STAFF REPORT

REGIONAL CENTER HEARING EXAMINER - HIGH IMPACT CASE

Case Number	2022-REG-071
Address (approx.)	227 West 14 th Street, 1355 North Senate Avenue, 1302, 1310 and 1318 North Capitol Avenue
Location	Center Township, Council District # 11
Petitioner	Indiana University Health, Inc., by J. Murray Clark
Zoning	CBD-S (RC)
Request	Regional Center Approval for provide for the construction of a mixed-use support building to be used as a parking garage, loading dock and logistics space, commercial office and retail uses, and bulk medical gas storage in an exterior yard along 13 th Street. The building would be five stories in height, with alternate building heights up to eight stories.

Site Plan (top); Landscape plan

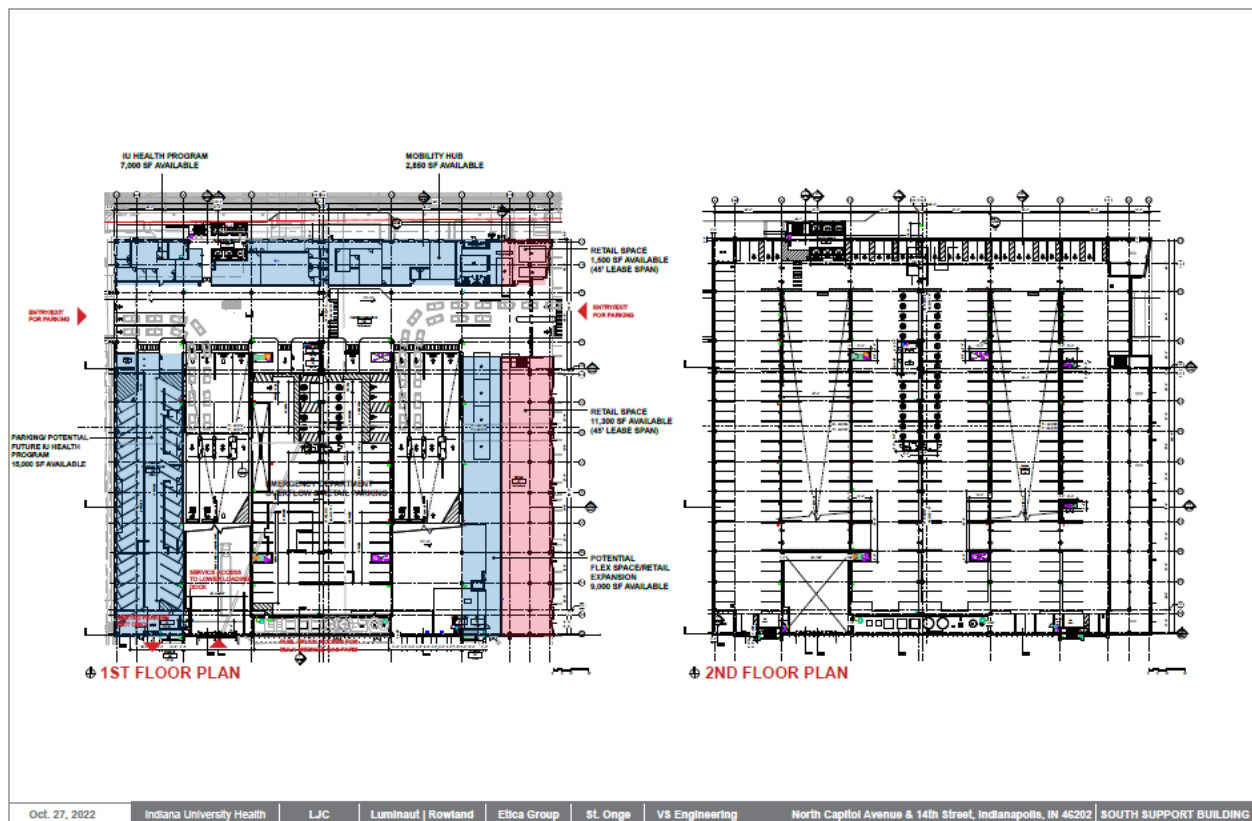
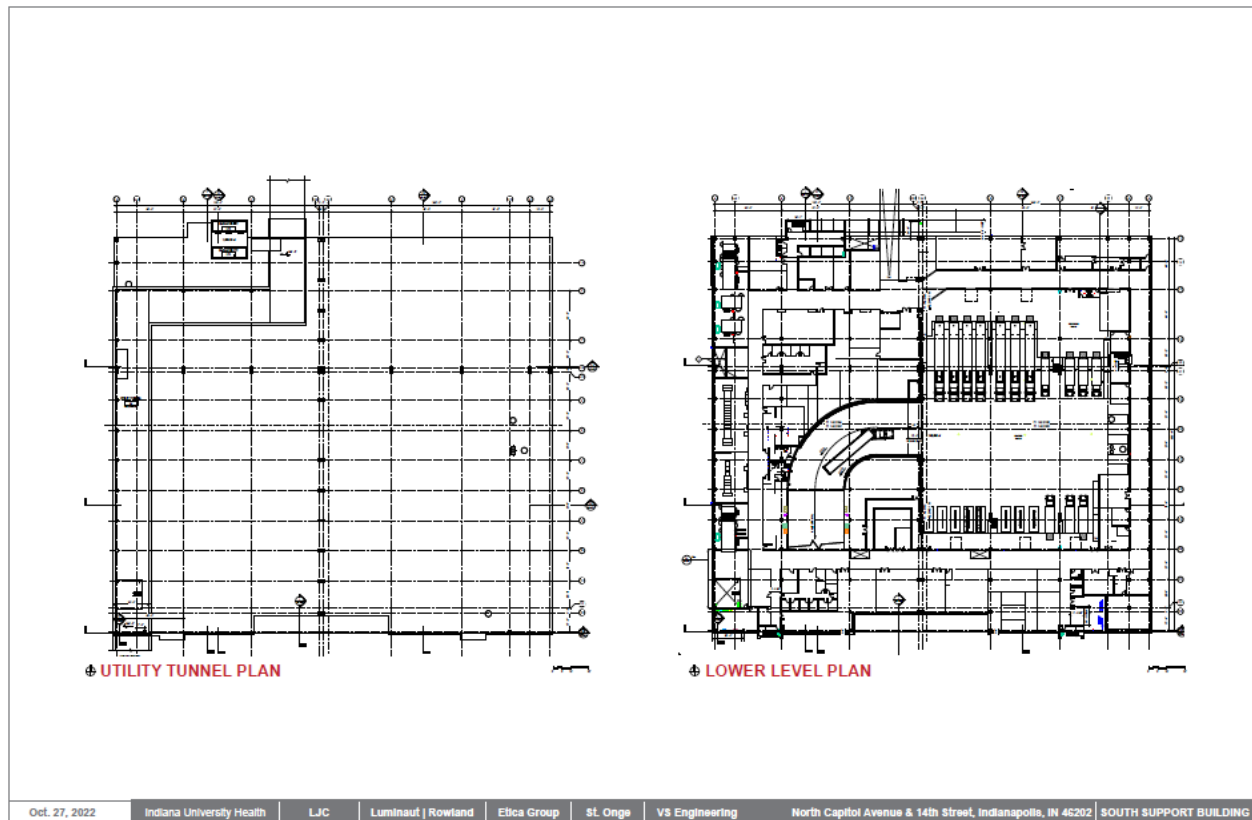
1. While a landscape plan has been submitted, it does not detail plant species. Staff requests that detailed landscaping plan be submitted and subject to planning staff review and approval, prior to installation. (Guidelines US 1.3.2, CA 4.6.1, CA 4.6.4, CA 4.6.5, and CA 4.6.7 apply).

1. Summary items 1 and 2 must be met.
2. Address numerals shall be installed on the building façade prior to occupancy of the building, per CA 2.5.8.
